We refer to the proposed redevelopment of Oxford and Verona Street, for which application for approval was submitted under State Significant Development Application SSD 87245208. This letter provides responses to further information required by Heritage NSW and Sydney Water which must be addressed as part of the Response to Submissions (RTS) package to DPHI.

Table 1 Response to RFI

Project
Verona, Paddington

Drawing No.
A 207

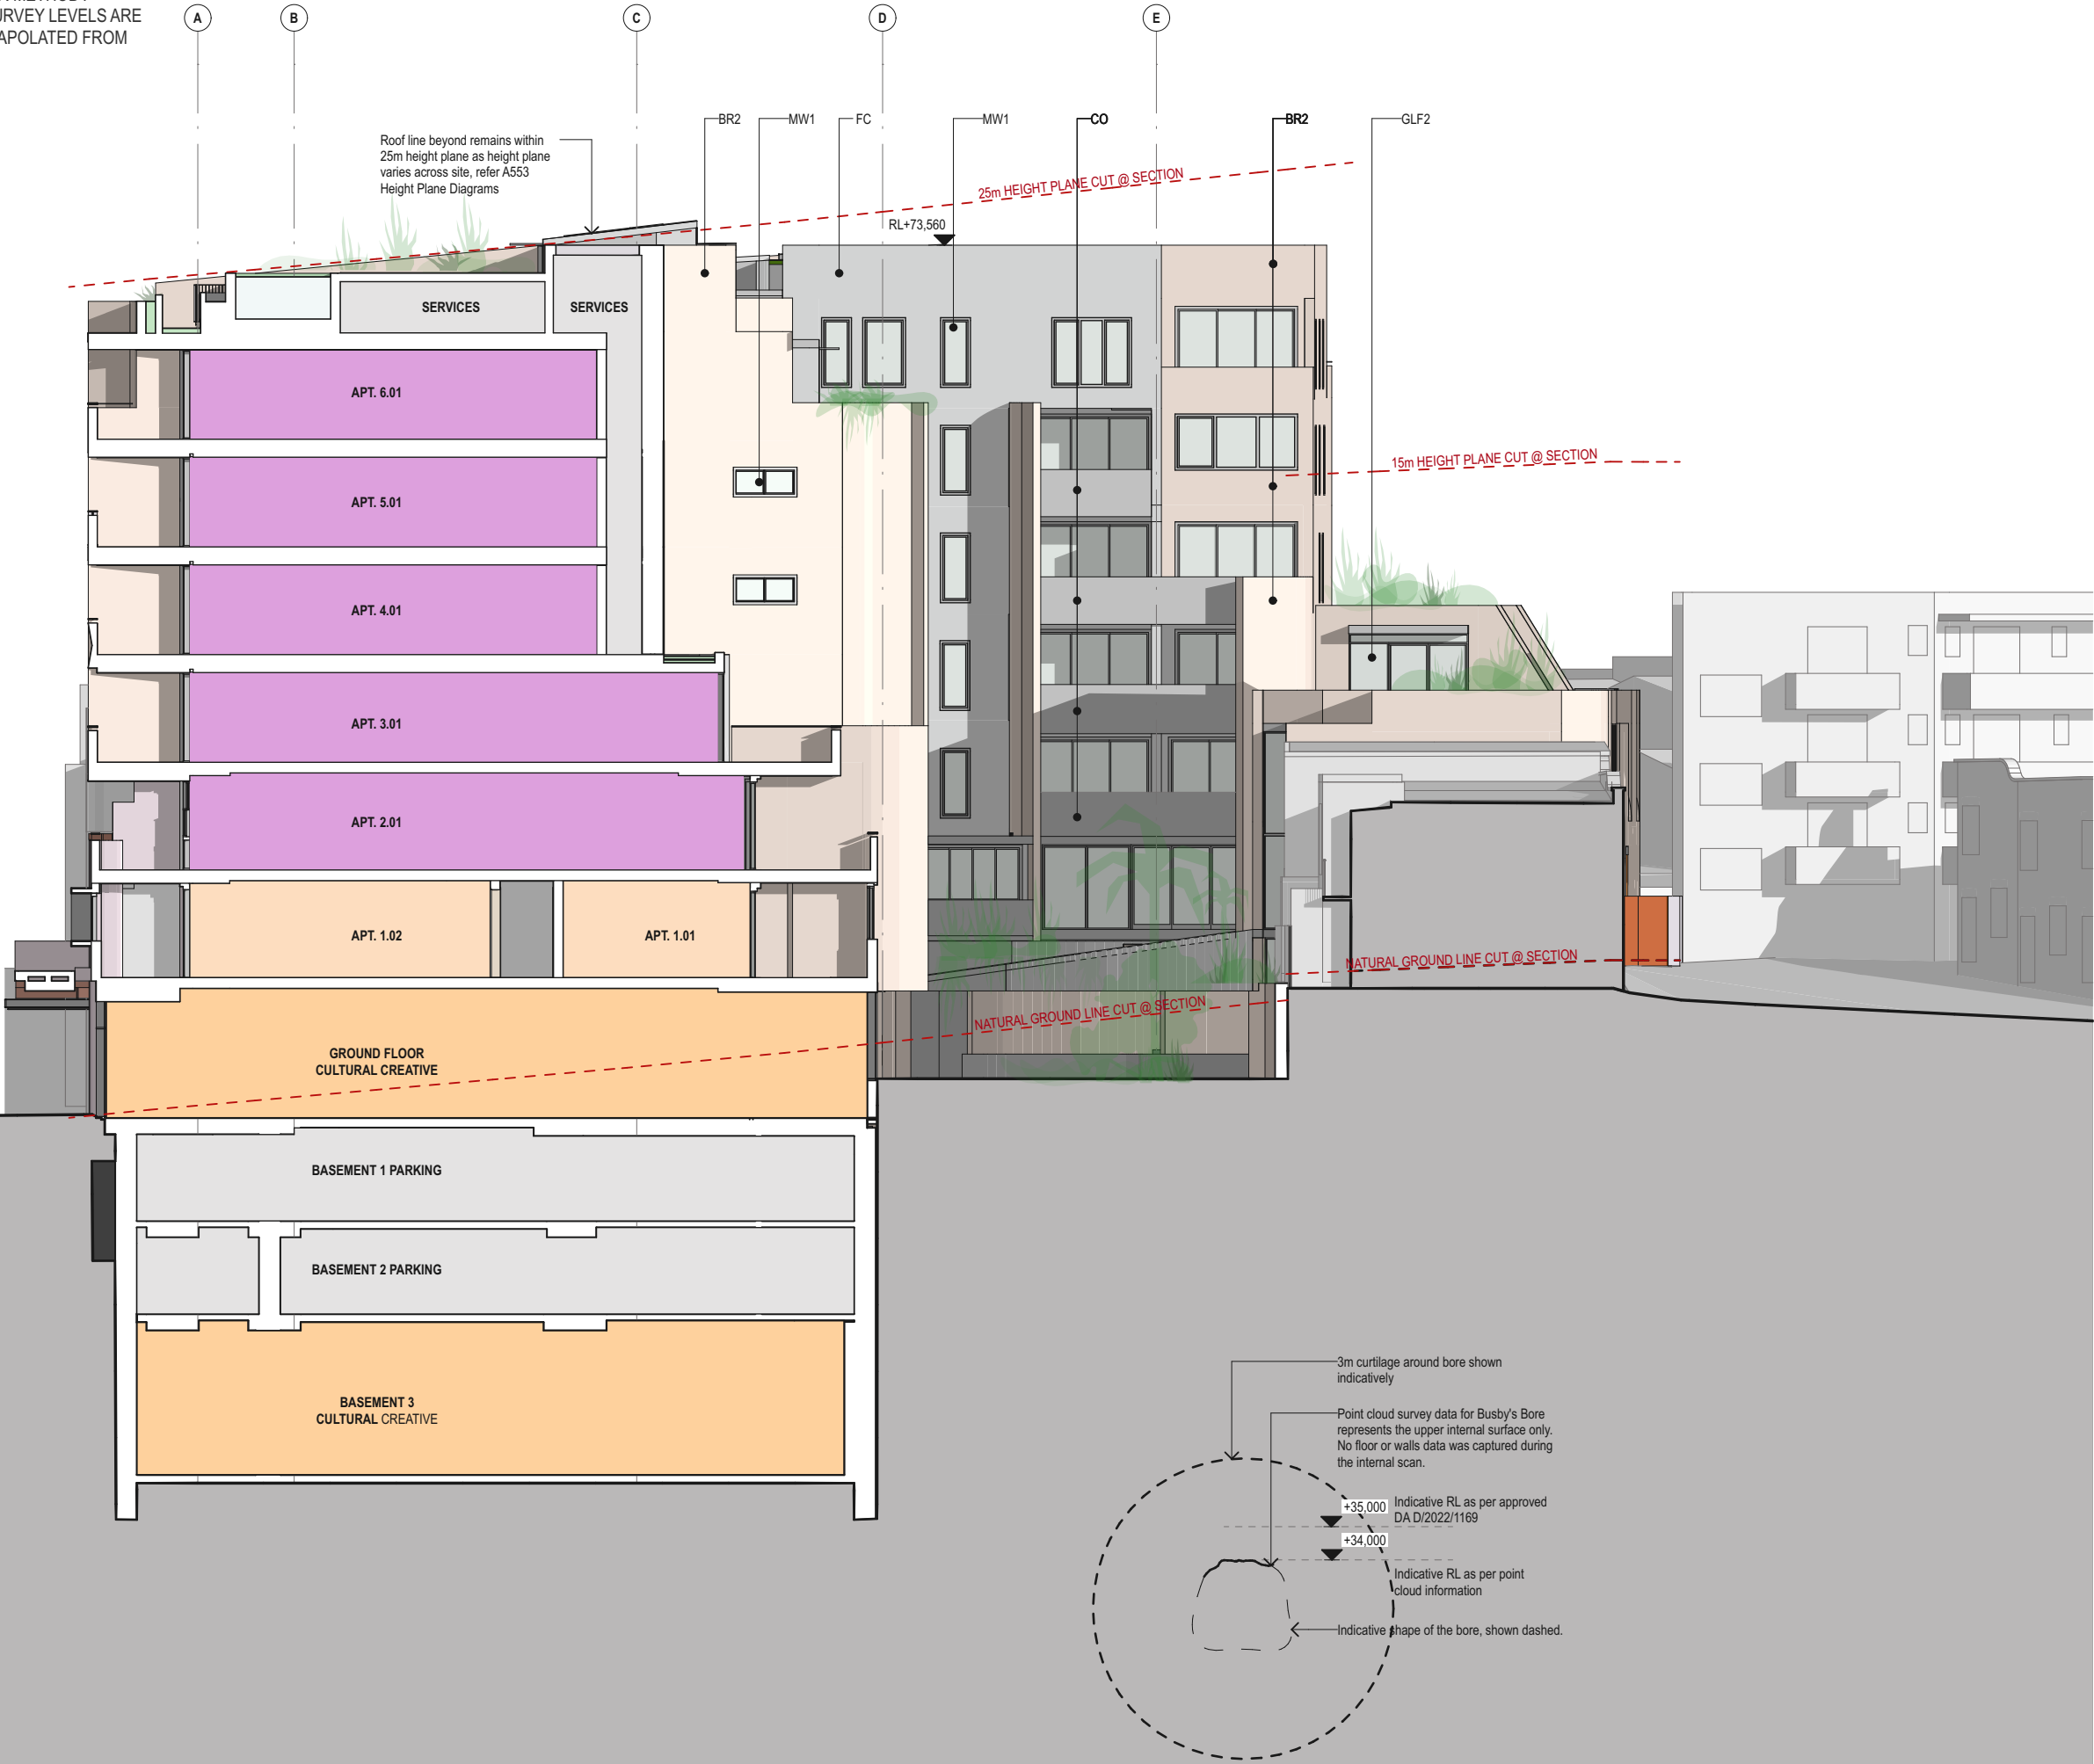
- a)** The proponent should show the location of Busby's Bore in the Section plans, demonstrating the proposed separation from basement excavation and construction and relative depth compared with the proposed new building basement levels.
- b)** The proponent should provide Sydney Water with their construction methodology for review by the Sydney Water Heritage Team – this methodology must outline how Busby's Bore will be protected from potential impacts during excavation and shoring/piling works and throughout construction and beyond. The methodology must demonstrate how Busby's Bore

a) The Section Plan – Cultural Creative & Courtyard (see page 6) dated 10/04/2026, Drawing No. A 207 provided by TZG shows the location of Busby Bore and curtilage in relation to the proposed basement works.
